### **REGULAR MEETING OF THE PLANNING COMMISSION**

**Monday, August 05, 2024**

A. Site Plan Review: VLO-24-02 (44 E. Flint) Mixed-Use Development

**Subject: VLO-24-02 44 E. Flint, Site Plan Review #2**

DRAWING:  
**C-2**

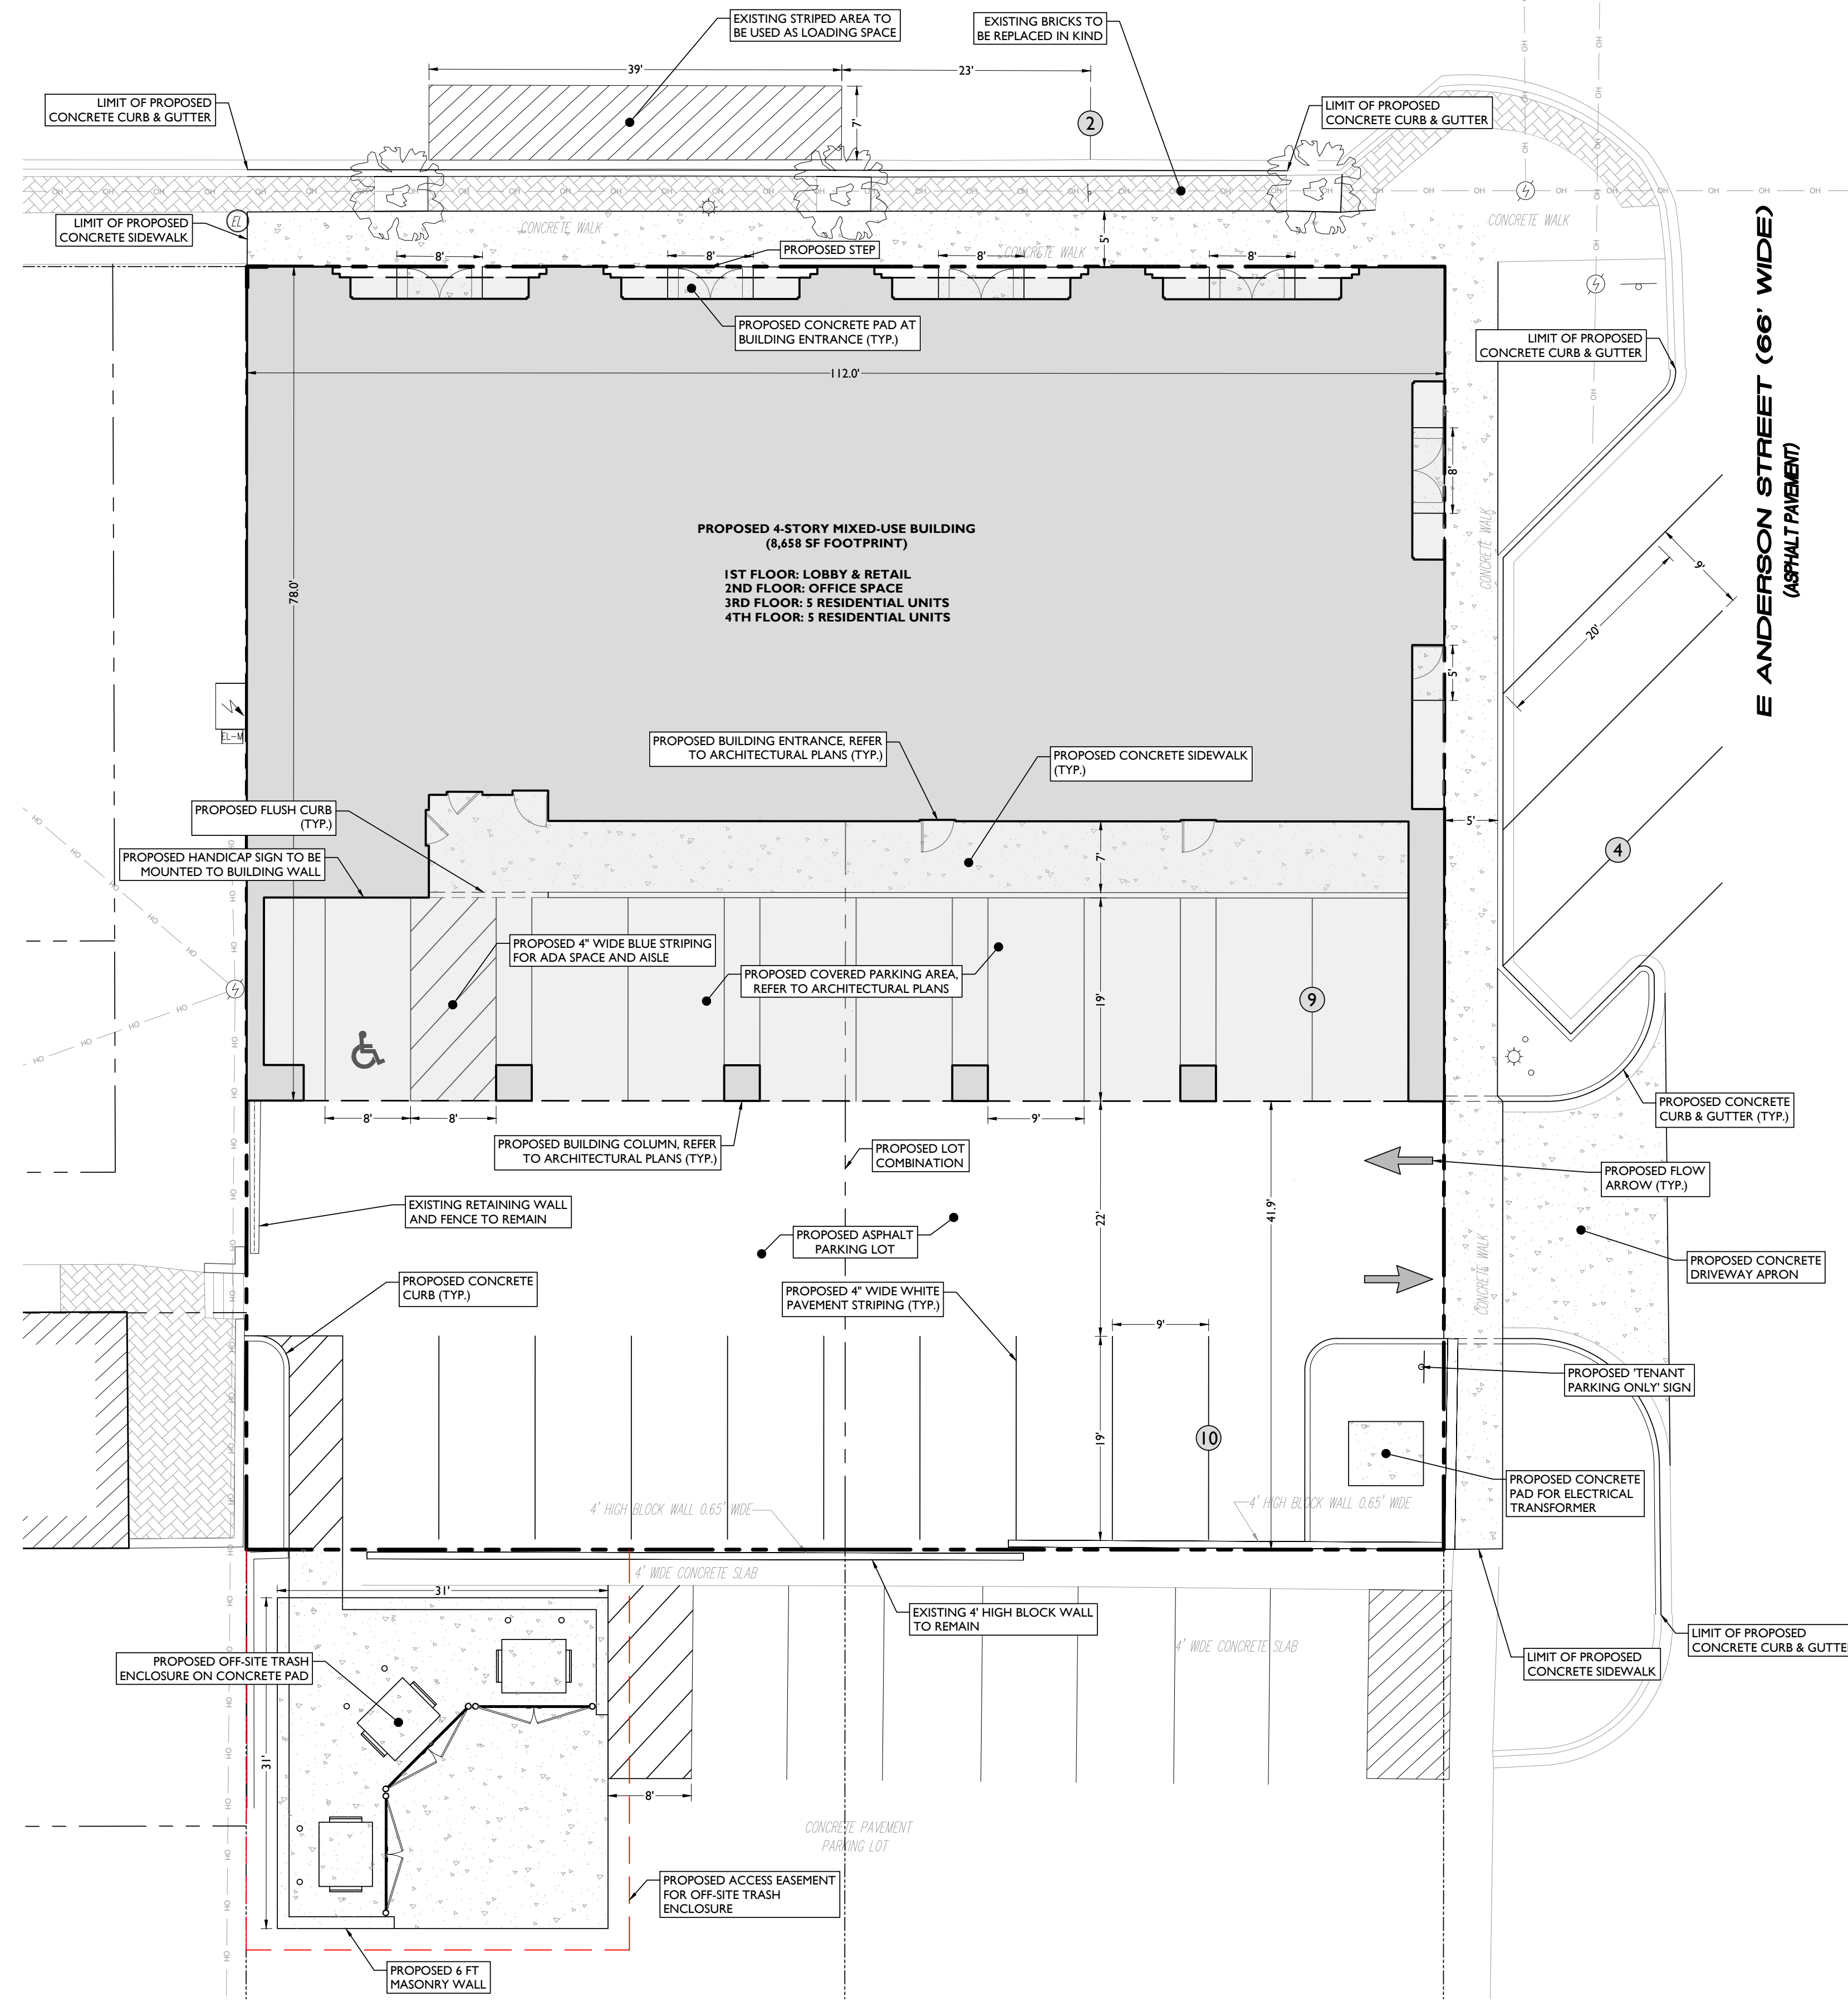
1. We note that some but not always all of the existing utilities, easements, and key information is shown on various sheets of the site plan set. Please include all existing utilities, easements and relevant information as underlying topo on the plans when submitting for engineering review.

**The site plan has been superimposed onto a survey of the site. The property lines, bearings and distances, and existing easements are indicated on Sheet C-2 of the Site Development Plans. The existing and proposed utilities are indicated on Sheet C-5 of the Site Development Plans.**

**The parcel ID has been updated to show the correct label. Please refer to Sheet C-2 of the Site Development Plans.**

**The topographic survey has been updated to show features 100 FT beyond the property lines. Please refer to Sheet C-2 of the Site Development Plans. The existing screen wall is shown on the site plan. Please refer to Sheet C-3 of the Site Development Plans. The zoning of adjacent parcels has been shown on both the cover sheet and on the existing conditions survey of the area. Please refer to Sheets C-1 and C-2 respectively of the Site Development Plans.**

DRAWING: **C-3**

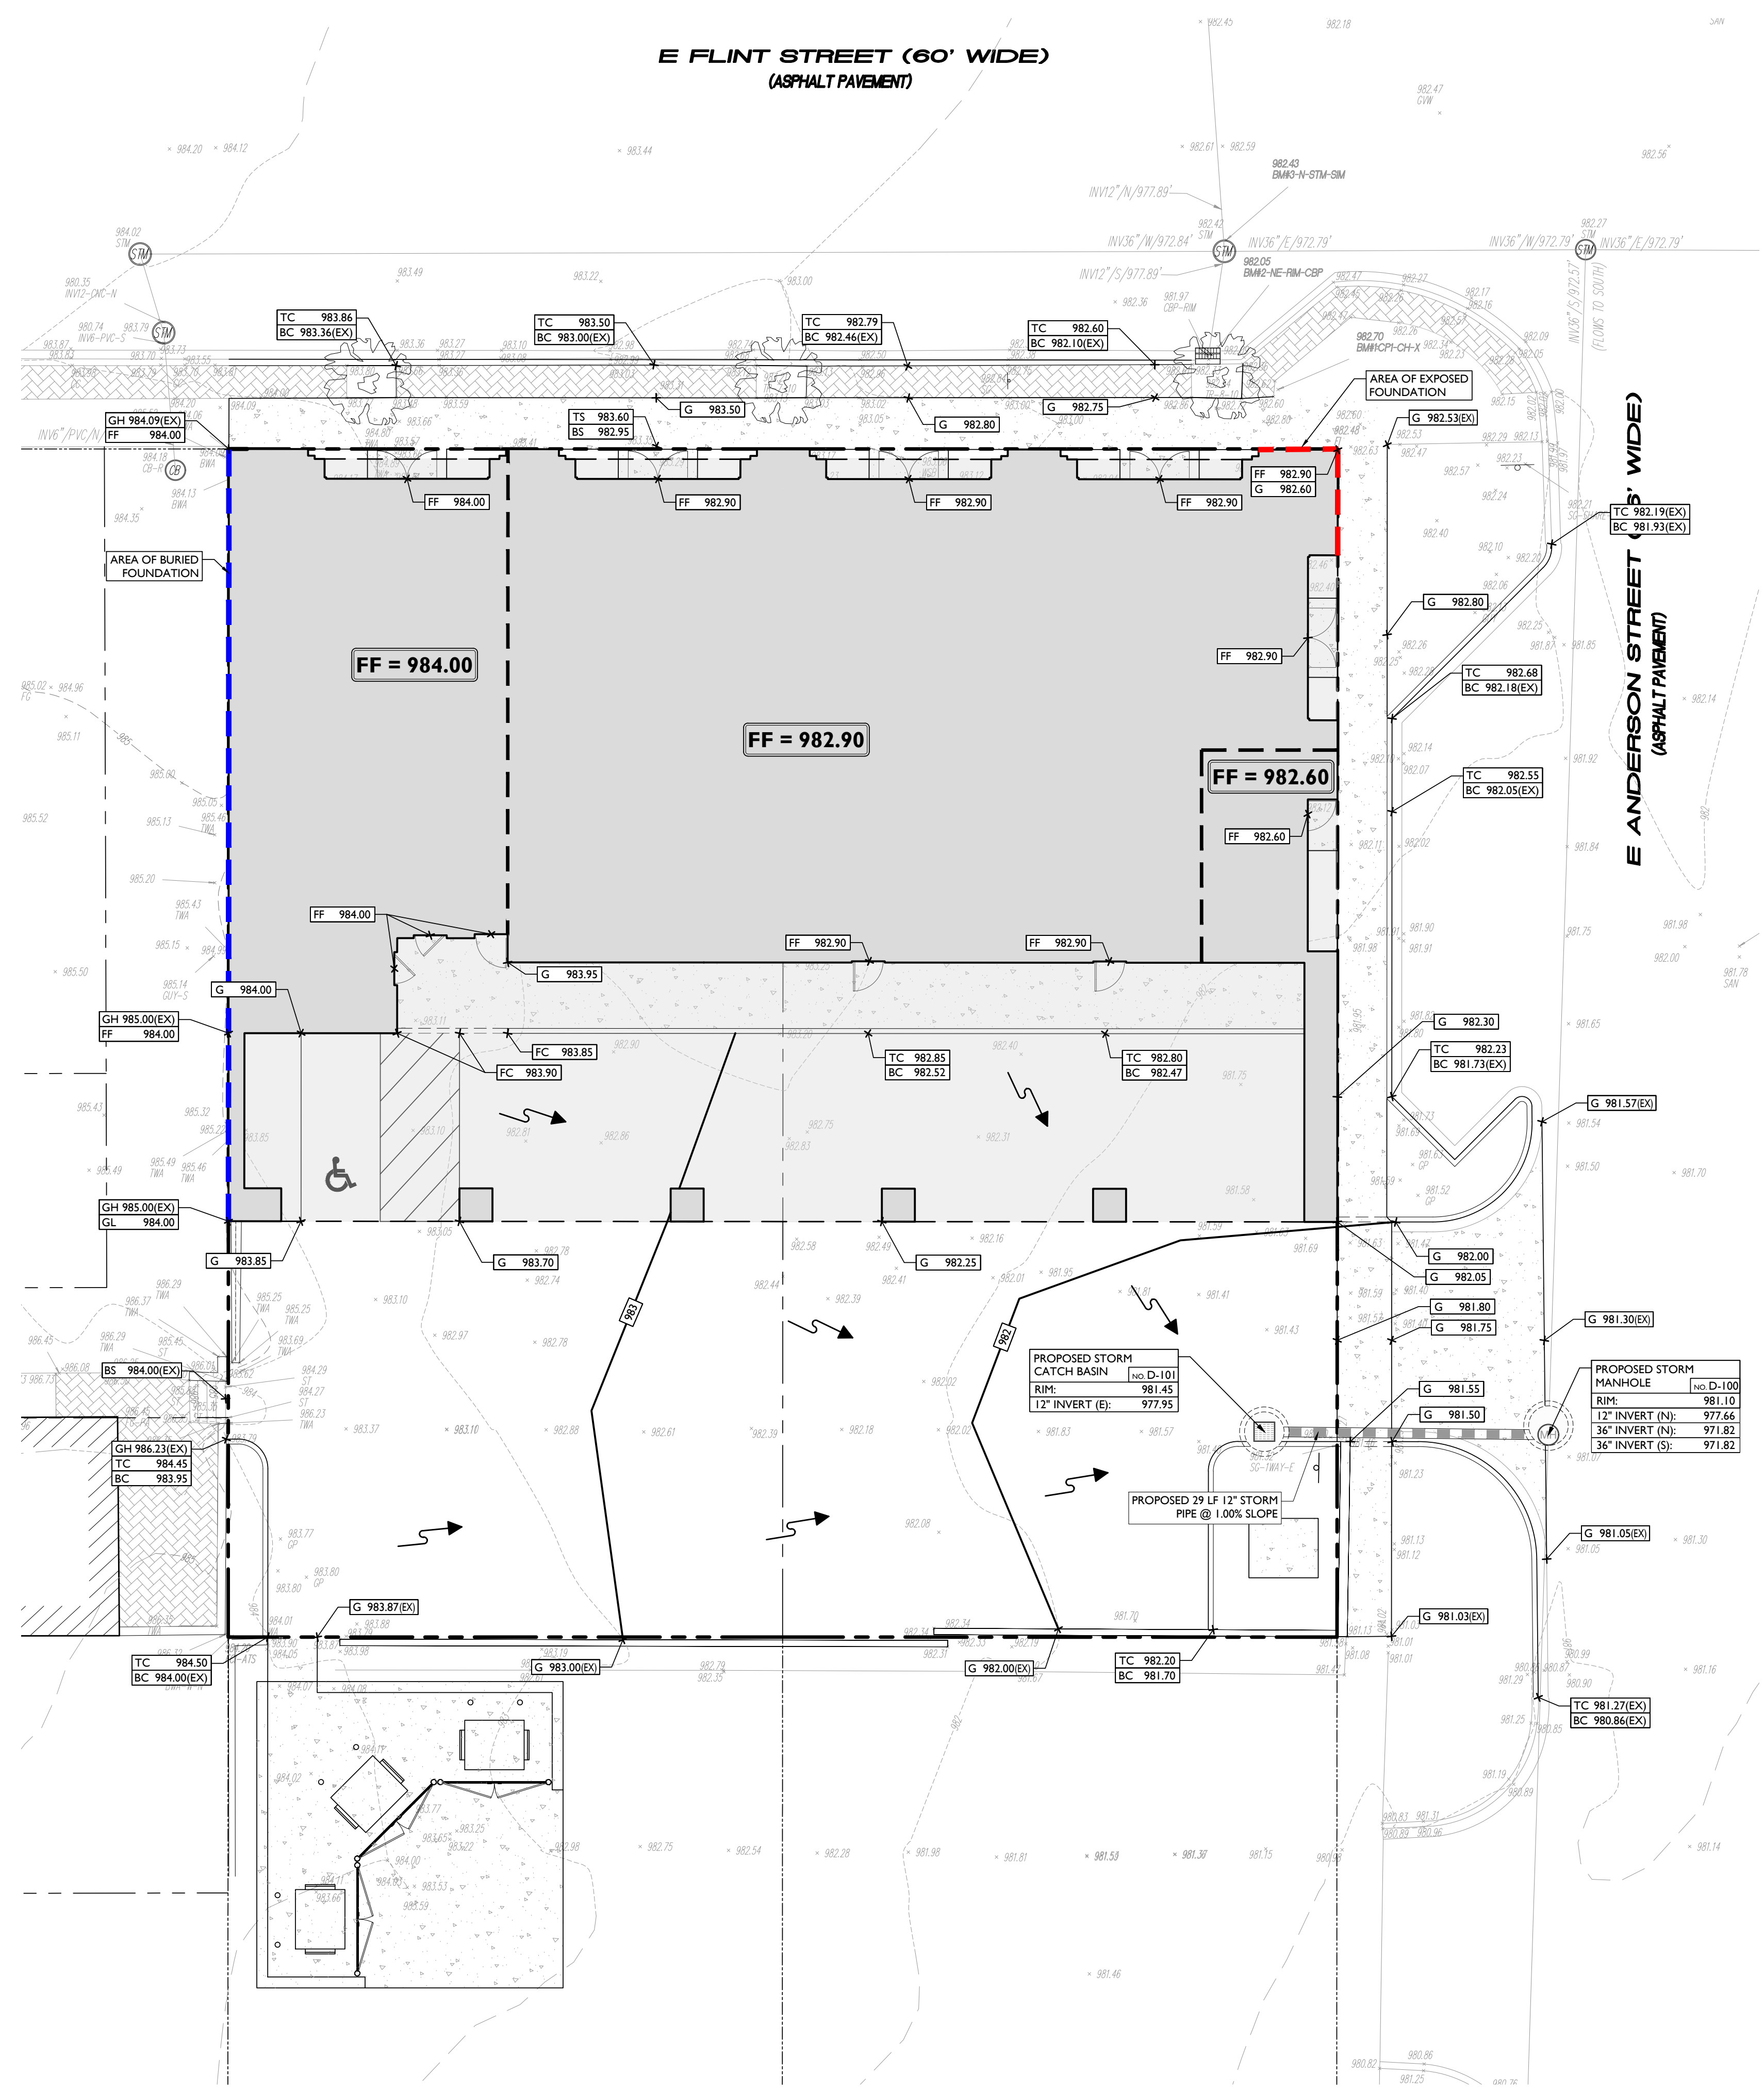
3. We recommend the site plan set clearly state the proposed changes in parking count on the adjacent DDA parking lot to the south as well as the on-street parking along Anderson. It appears that 3 spaces will be lost on Anderson and at least 2 spaces lost in the DDA lot. Please clarify.

4. Additionally, it appears that the proposed angle parking on Anderson may narrow the traveled portion of the street to less than 26' in width, which is the minimum width required by fire code for an aerial access road. Please provide dimensions and show the existing parking spaces on the east side of the street. Approval by the Fire Marshal for emergency apparatus access is required.

- 9. We note that the existing landscaped island in the DDA parking lot south of this site will be replaced with the proposed trash enclosure, as shown on sheet C-3, though the existing underlying landscaping is not shown.

- 10. The proposed trash enclosure indicates a 6' masonry wall along three sides with gates in the front. Provide details and cross section.
- 11. The proposed water service line is shown connecting to a 6" water main in Flint Street. This line is abandoned. The correct connection would be to the 12" main shown on the survey.

**Dimensions between the building walls and property lines have been provided. Please refer to Sheet C-3 of the Site Development Plans.**

**The existing wheel stops have been removed and new concrete curb has been proposed along the existing eastern sidewalk. The curb accommodates new angled parking spaces which are intended to prevent vehicle overhang along the existing sidewalk. Please refer to Sheet C-3 of the Site Development Plans.**

**The previously proposed 6 FT tall masonry screen wall is no longer being proposed. Please refer to Sheet C-3 of the Site Development Plans.**

**A trash enclosure has been proposed off-site near the southwest corner of the site parcel. Proper coordination with the adjacent property owner will be conducted prior to construction. Please refer to Sheet C-3 of the Site Development Plans.**

**The proposed sidewalk adjacent to the parking spaces on site is 7 FT wide. Please refer to Sheet C-3 of the Site Development Plans.**
